**January 14, 2014**

**RE: Decision on Application for Amendment of Tintina Alaska Exploration, Inc.  
Exploration License No. 00710, Black Butte Copper Project**

APPENDIX A Tintina Black Butte Copper Project, Response to Comments

**Figure 7**  
**Surface Water and Groundwater**  
**Monitoring Sites and Wetlands**  
 Black Butte Copper Project  
 Meagher County, Montana

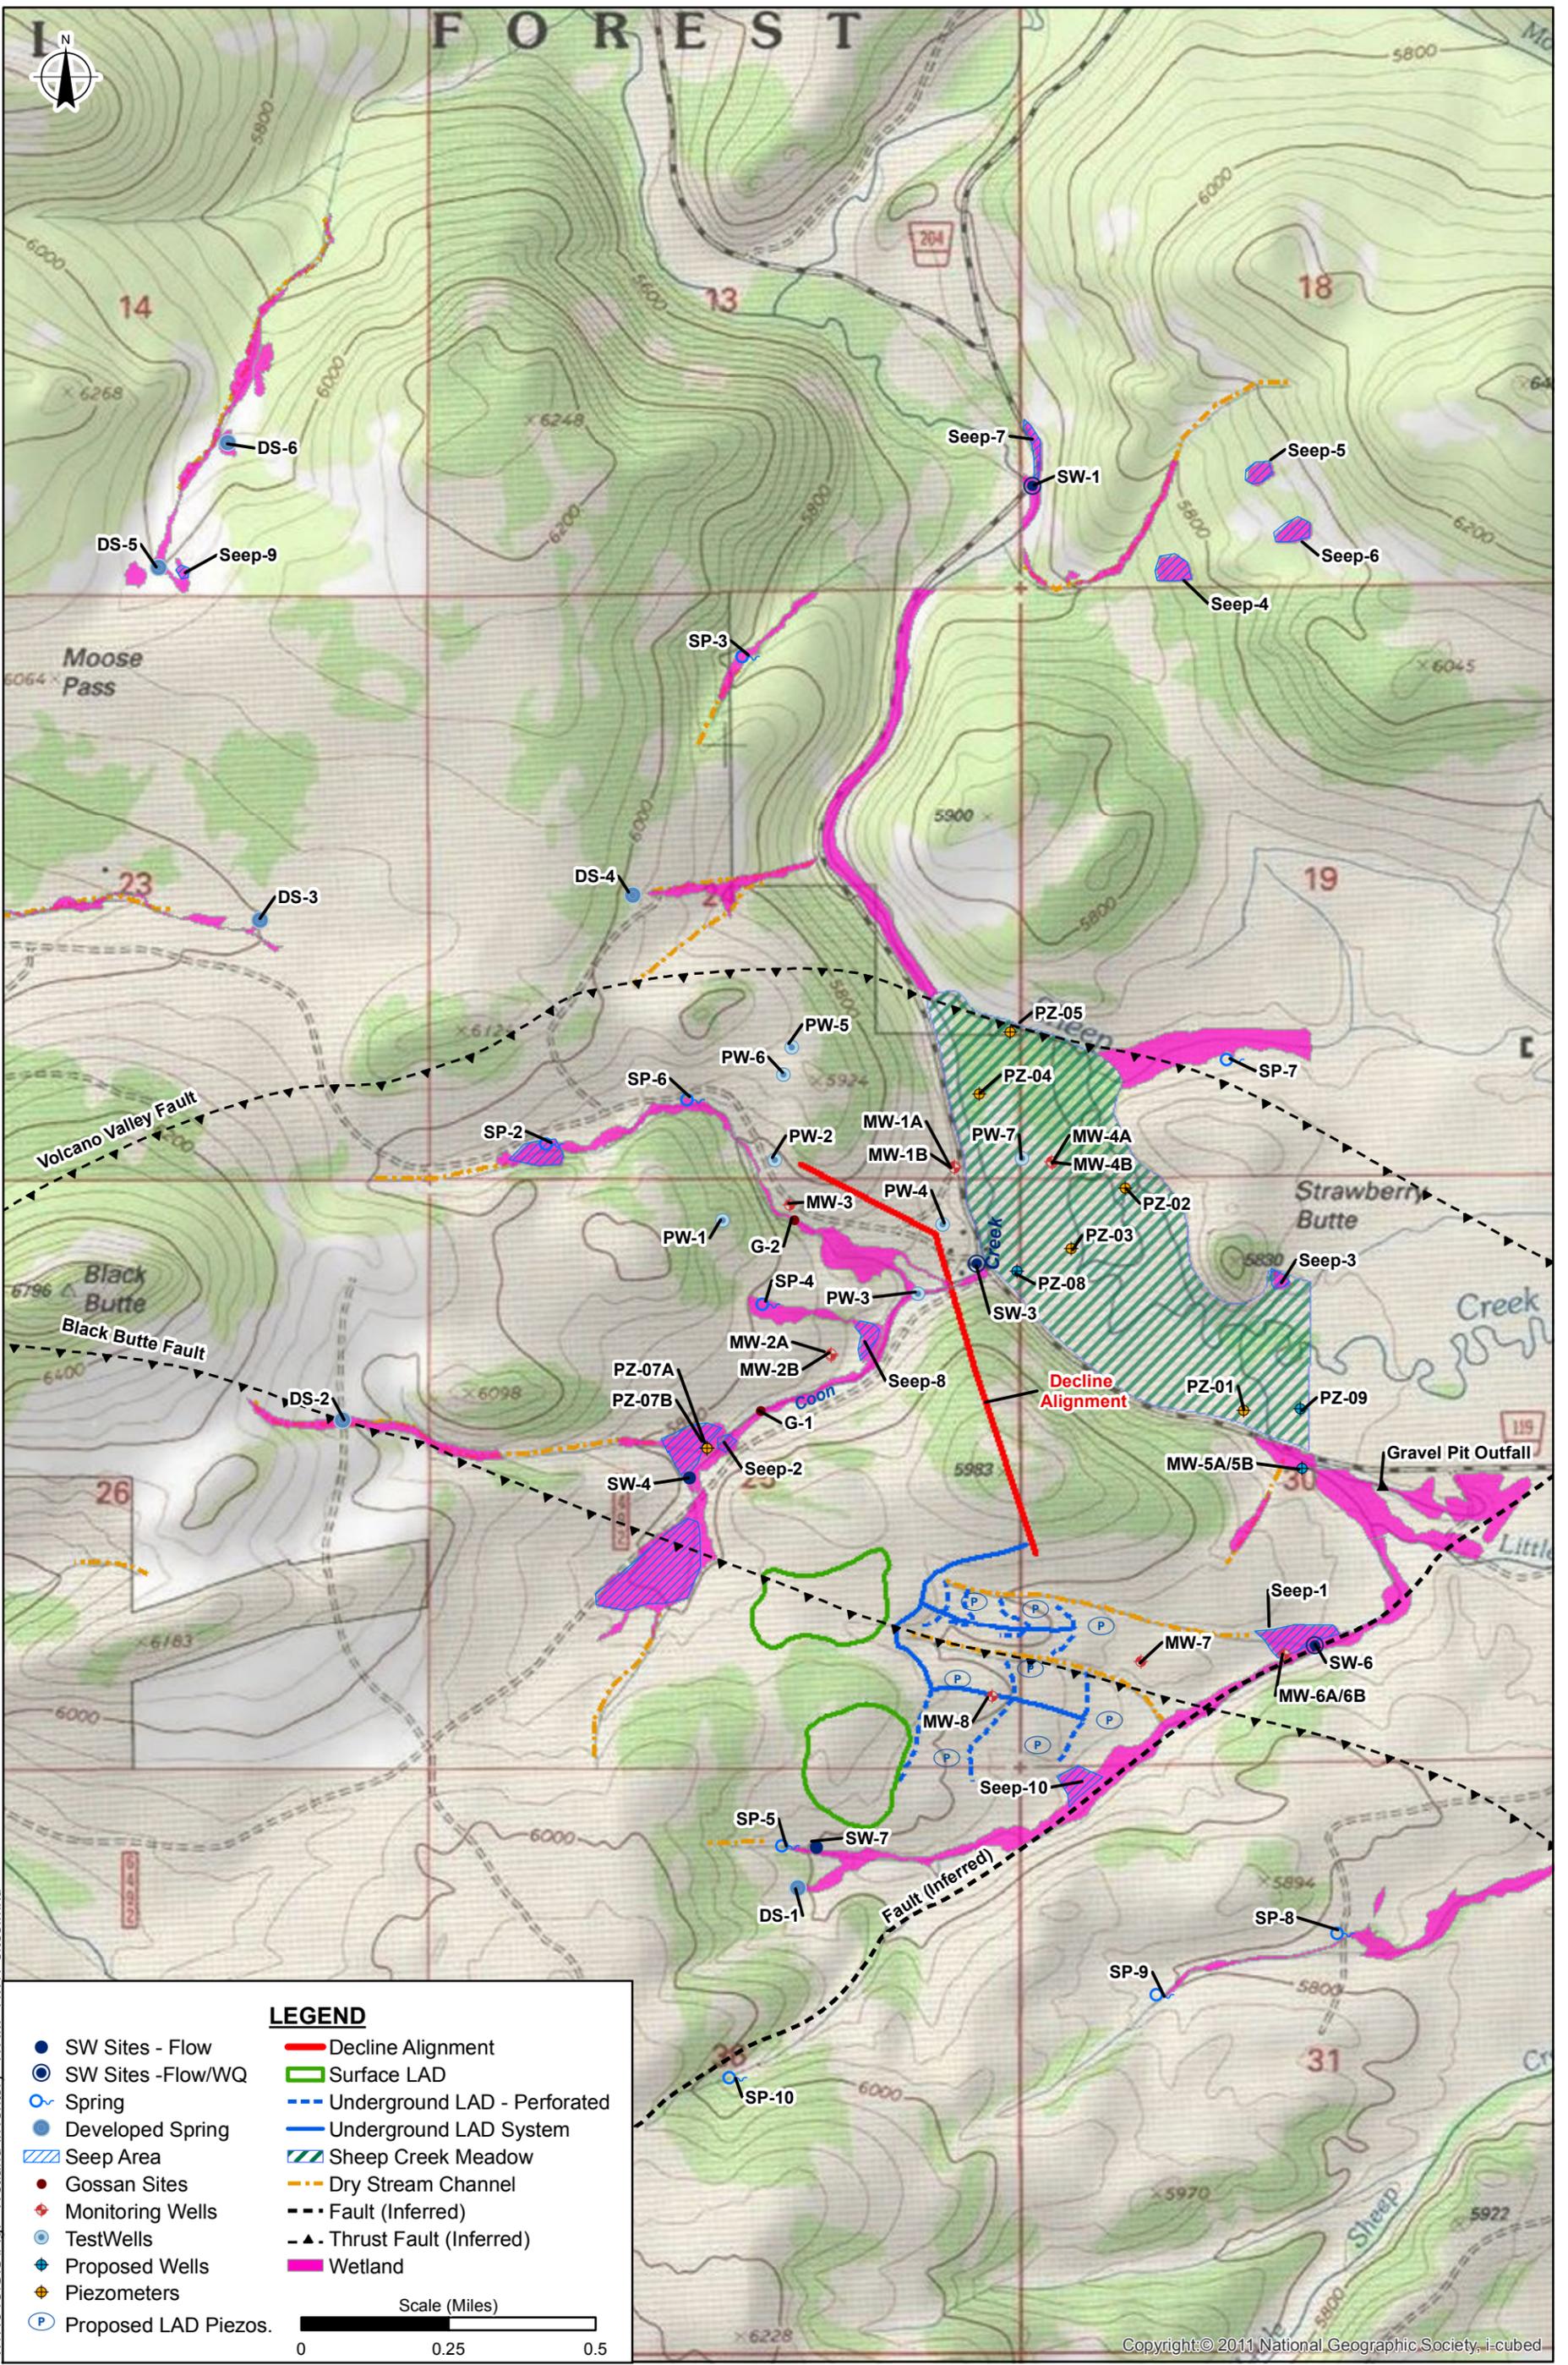
10. Tintina is required to place the LAD area more than 400 ft away from any wetlands. The locations of the underground LAD drainfield lines shown on Figure 7 are conceptual. Prior to their installation, Tintina is required to use data from the monitoring wells and piezometers near the wetlands and the LAD site to finalize drainfield design locations where the applied water will infiltrate to groundwater rather than report to surface water. Tintina is required to notify DEQ prior to beginning installation of the underground LAD system so that DEQ staff can be on-site for oversight. Tintina is required to submit as built drawings of the underground LAD system to DEQ.

The LAD area would be more than 400 ft away from any wetlands. The locations of the underground LAD drainfield lines shown on Figure 7 are conceptual and prior to their installation DEQ would require that the data from monitoring wells and piezometers near the wetlands and the LAD site be used to select drainfield locations that would avoid impacts to wetlands and surface water. Tintina must notify DEQ prior to beginning installation of the underground LAD system so DEQ staff could be on-site for oversight. Tintina would be required to submit as built drawings of the underground LAD system.

**SIMULATED DRAWDOWN**  
ADIT DISCHARGE 500 GPM

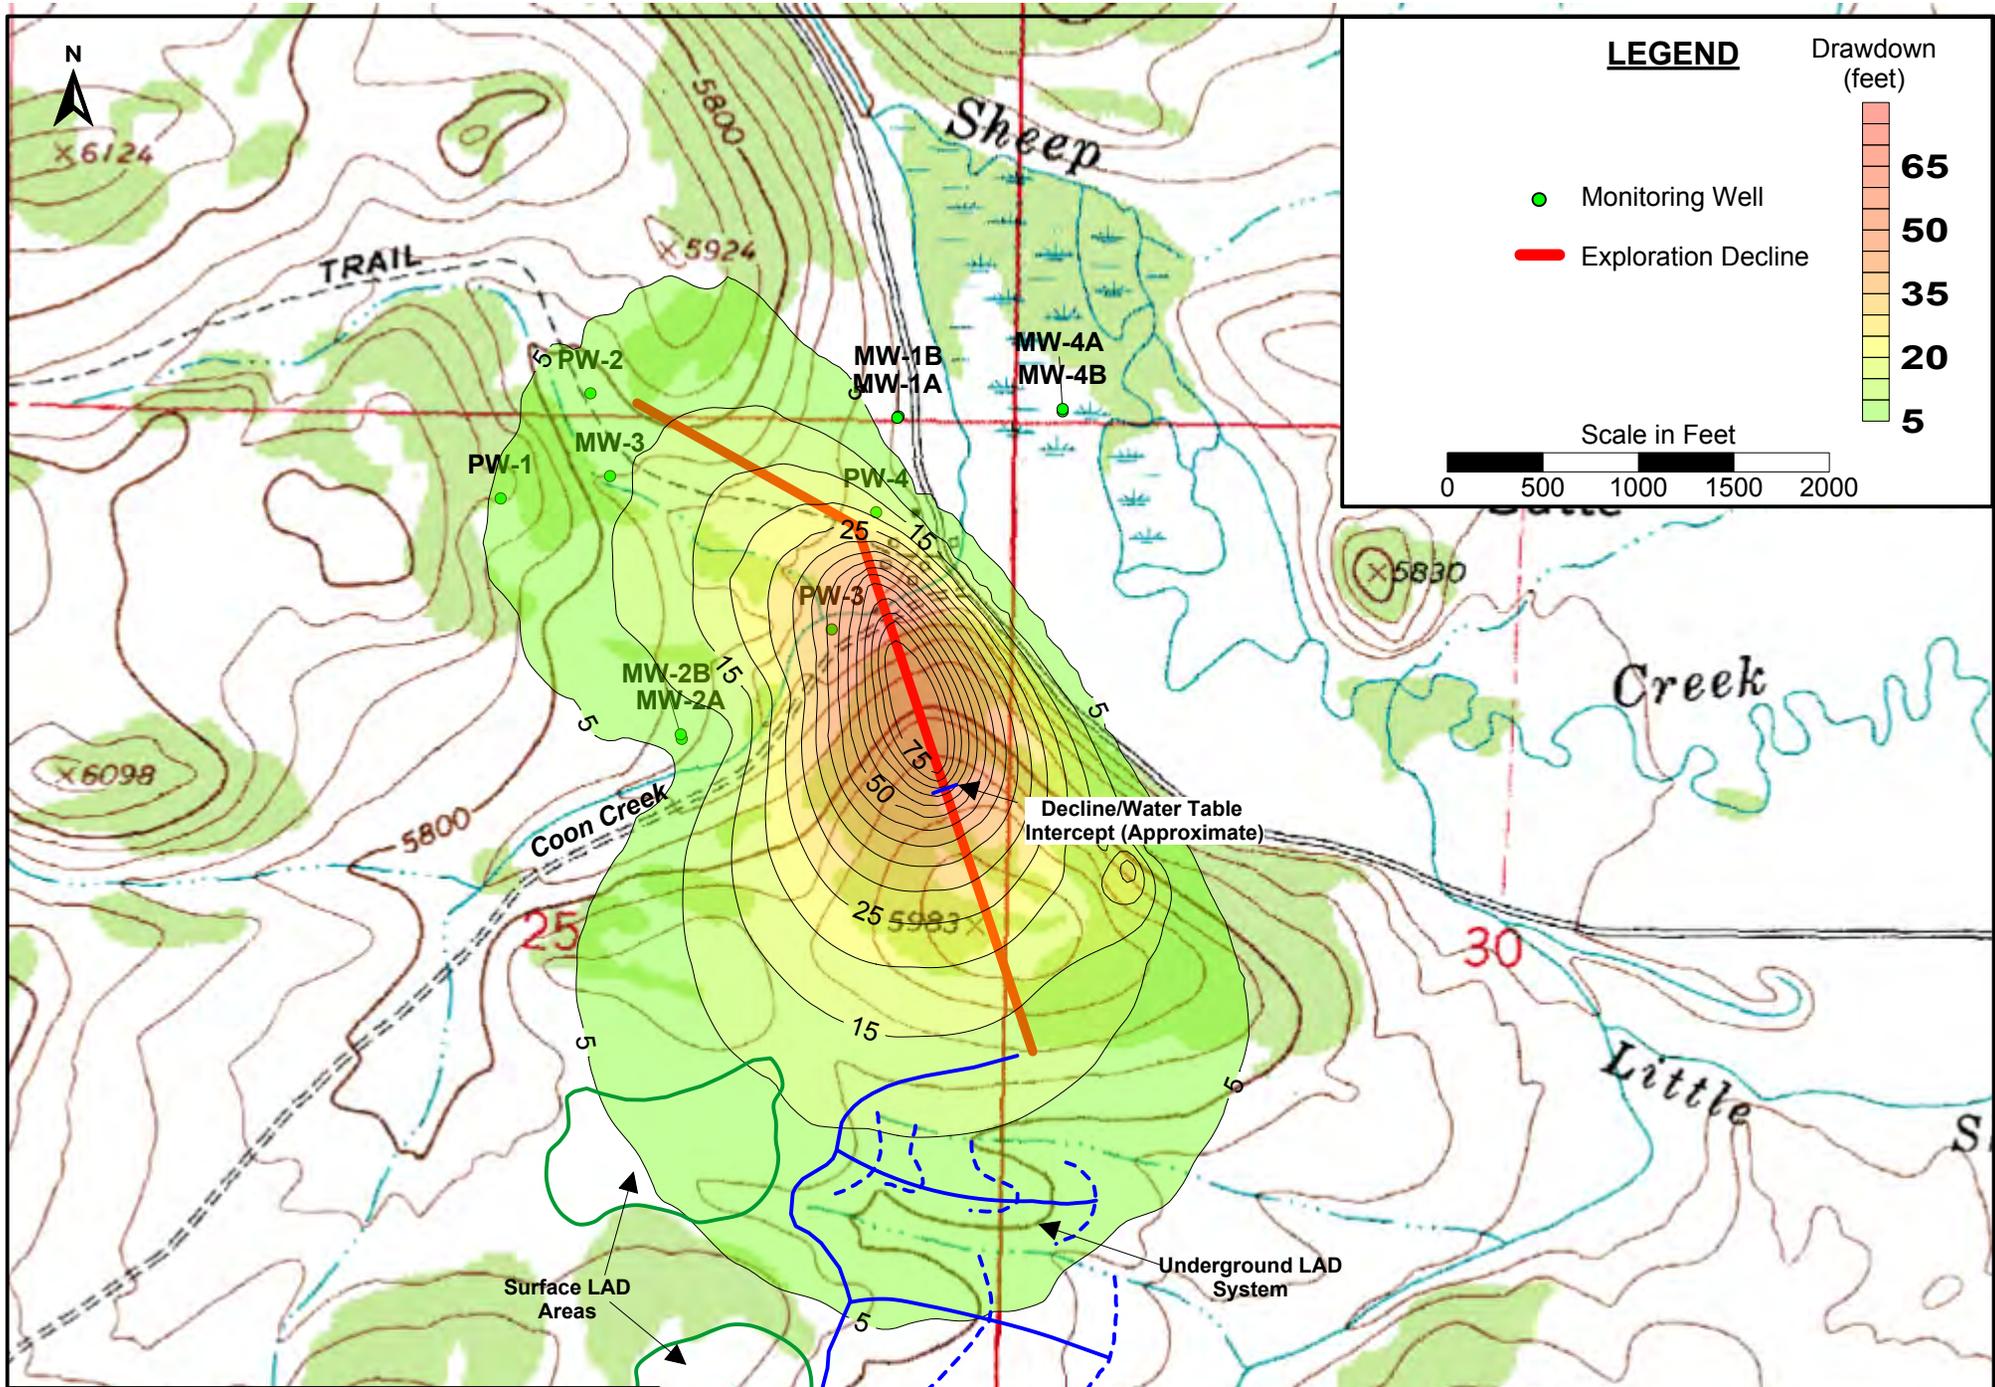
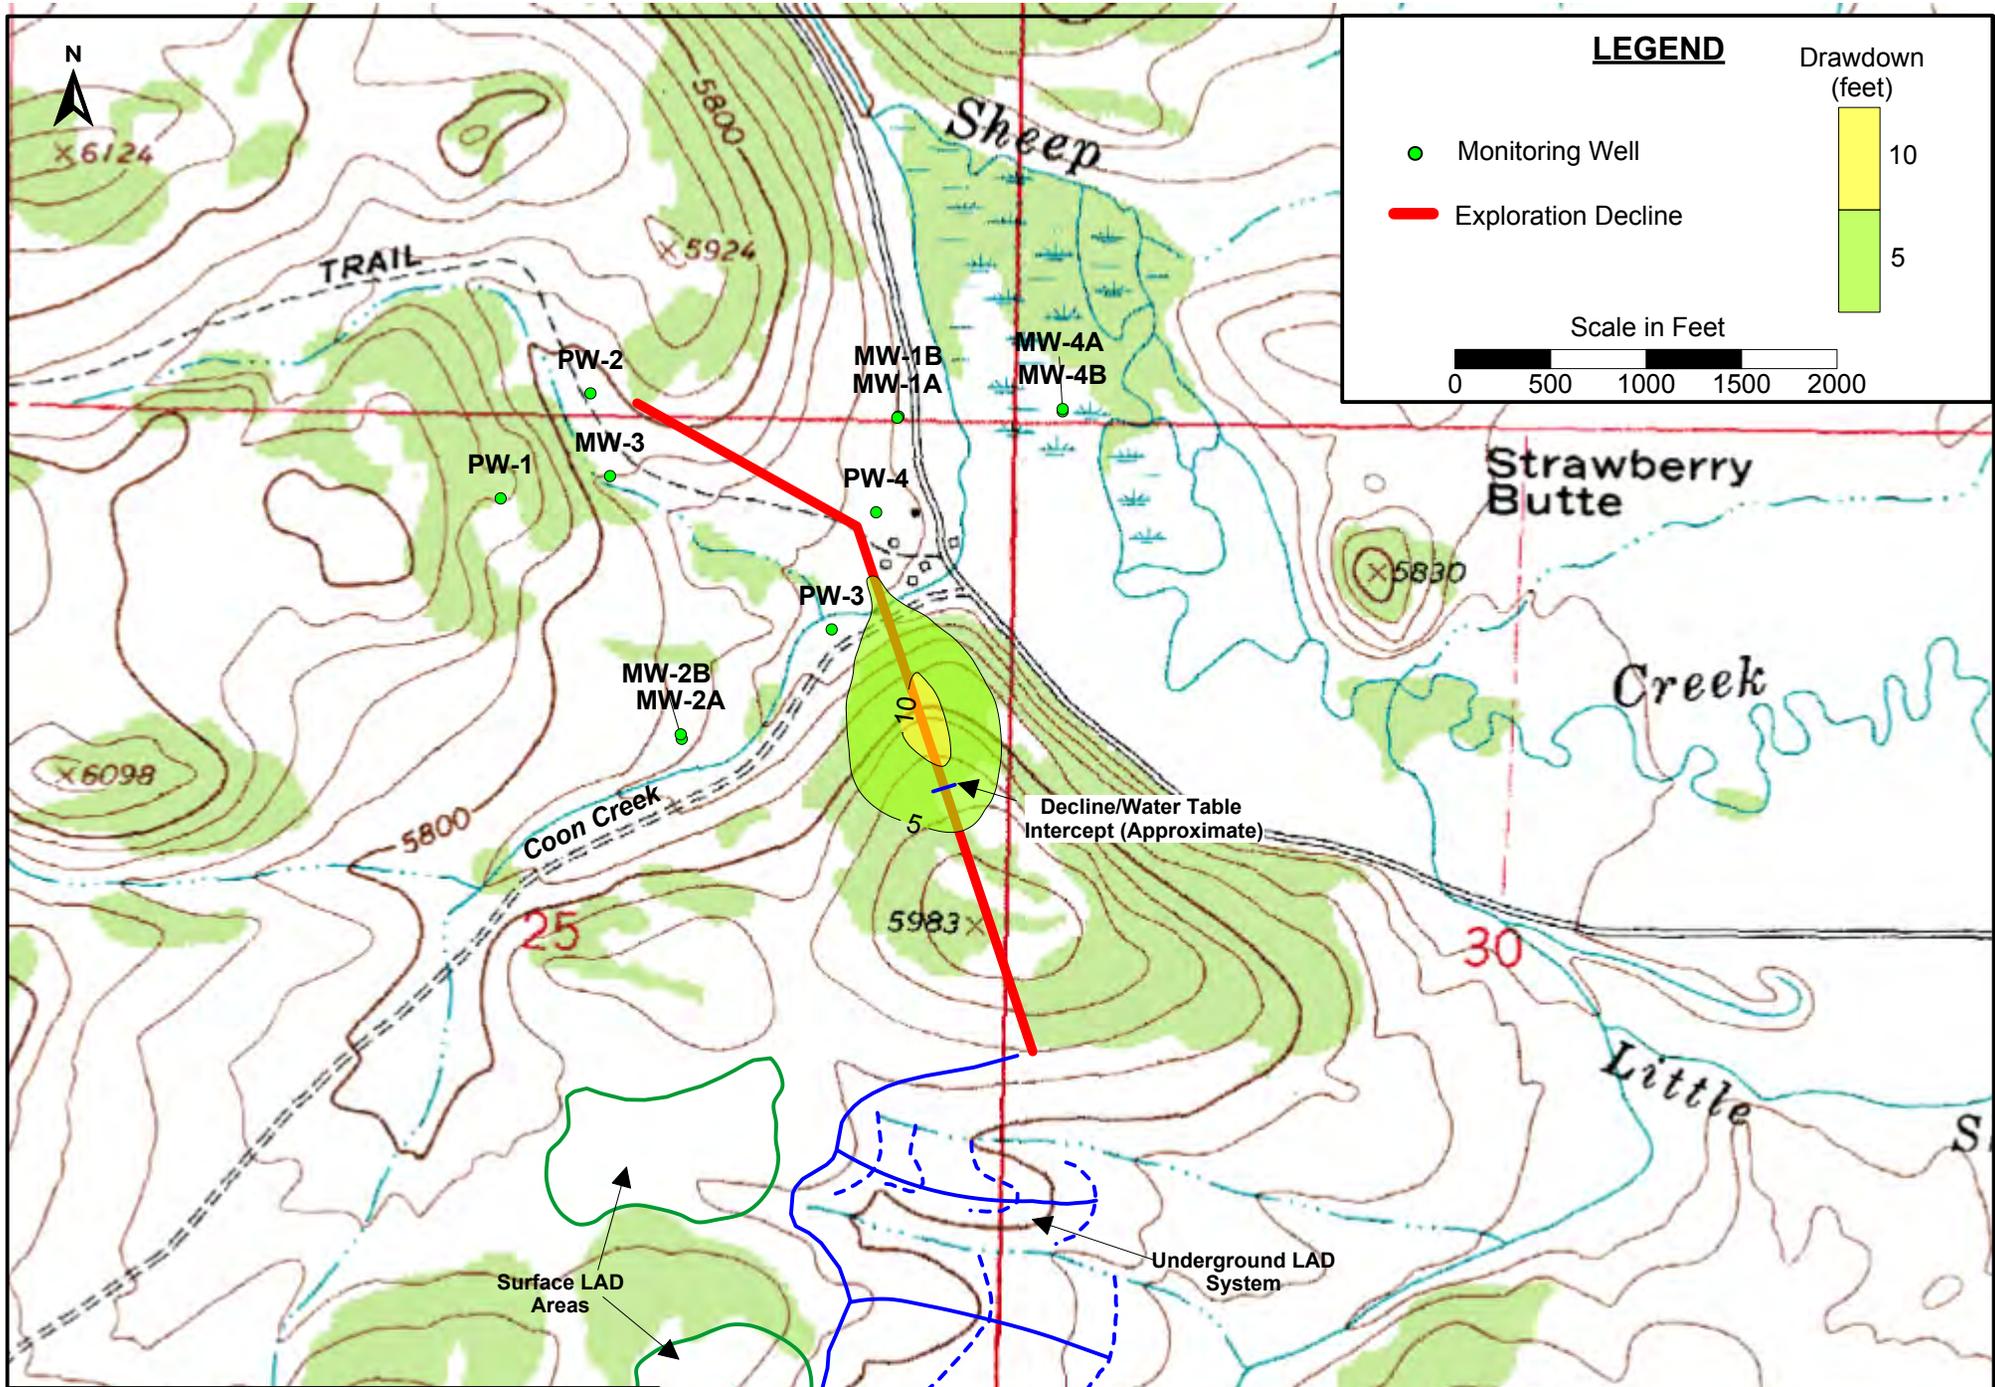
south and west of the exploration decline facilities (Figure 10 and 11, Final EA). This model uses porous media solutions, which are appropriate for regional bedrock models and bedrock that is highly fractured. If fractures are more discrete and are not well-connected a porous media solution can over-predict drawdown extent. Other limitations of this model are as follows:

Although the draw-down model's peak dewatering scenario of 500 gpm shows the cone of depression extending into the alluvial gravels of Sheep Creek (Figure 10), the following limitations of the model result in very conservative (high) drawdown predictions, particularly in outlying areas at the margins of the model domain:

Re-infiltration of mine water via the LAD system was not simulated. Since virtually all of the water intercepted by the decline would be re-infiltrated to the shallow groundwater system through the proposed LAD areas (Figure 7) between 500 and 2400 feet south of the portal area. This discharge would offset any drawdown effects near the LAD area.
